System No. FF-D-1175

WEBSTER UNIVERSITY ISB	
PROJECT NAME	
8274 BIG BEND BLVD	
ADDRESS	
NUMBER	
WEBSTER UNIVERSITY	
OWNER	
CANNON DESIGN	
ARCHITECT / ENGINEER	
Devin Gates	
SUBMITTED BY	
0784460-004	
CONTRACTOR / CM SUBMITTAL NO.	CANNON DESIGN SUBMITTAL NO.
	0784460
DRAWING / DETAIL REFERENCE	SPECIFICATION SECTION / PARAGRAPH
MANUFACTURER / SUPPLIER	ITEM / PRODUCT ID
REQUIRED DATE	PRIORITY
	CRITICAL

Product data and engineering judgement for firesafing at dynamic conditions only.

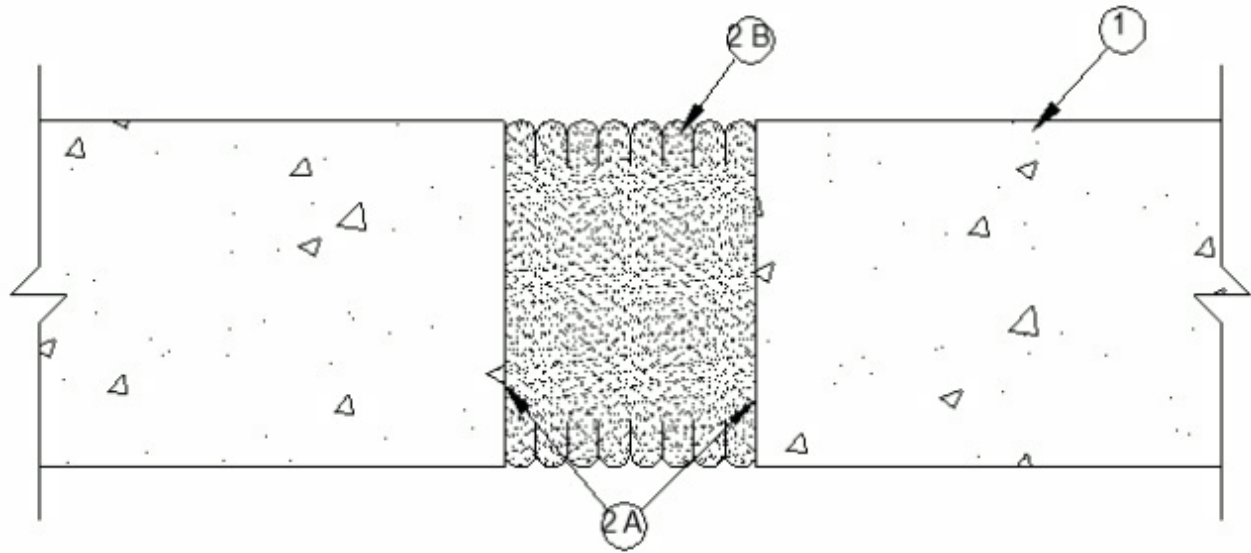
This engineering judgment (EJ) does not appear to include the back-pan and insulation mounted to and protecting the curtain wall spandrel. The fire resistive joint system EJ must be comprehensive including both the connection to the slab and the fire protection at the spandrel. The engineering judgment should be signed by a fire protection engineer, the one submitted does not appear to be signed by a fire protection engineer.

Additionally, the fire protection engineer should be considering the continuity of the fire resistive joint as it terminates and transitions to joints beyond this application area. Compatibility with adjacent systems and products will need to be verified by the construction management team as well as transition details should be provided as part of the engineering judgment.

Finally, as referenced in the engineering judgment itself, the final engineering judgment documents shall be approved by the local Authorities Having Jurisdiction (AHJ) and a record of this approval must be submitted for record as part of the submittal process.

We believe the AHJ may have issues approving the provided engineering judgment for reasons (not limited to) those listed below;

- 1.The EJ should be written and signed by a fire protection engineer.
- 2.The EJ should address the continuity of the protection between the EJ designated system and the adjacent systems.
- 3.The compatibility of components or products in EJ system and adjacent systems is addressed at transitions.
- 4.The EJ should address transition details between designated system it transitions.
- 5.The submitted EJ indicates it does not address the structural integrity of the joint in a fire. We believe this is a key performance requirement of interest to an AHJ.....that the joint will perform in a fire.
